MIL-F-85475(AS)
AMENDMENT 2
3 SEPTEMBER 1986
SUPERSEDING
AMENDMENT 1
13 December 1984

MILITARY SPECIFICATION

FUZE, GUIDED MISSILE, FMU-141/B

This amendment forms a part of Military Specification MIL-F-85475(AS) dated 12 December 1983, and is approved for use by the Naval Air Systems Command, Department of the Navy, and is available for use by all Departments and Agencies of the Department of Defense.

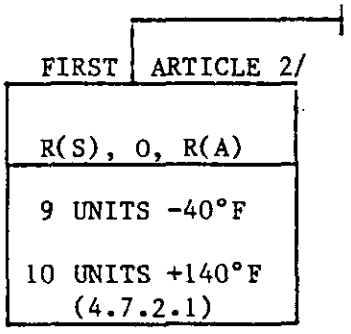
Figure 9, second horizontal line from bottom reading "6 PREPROD/1 INSPECT": Delete "1" and substitute "3". Figure 9, parallel to box labeled "R(S), S, O, R(A)," add the following:

Figure 9 NOTES: Add: "2/ Only mechanical operability tests shall be run at temperature shown."
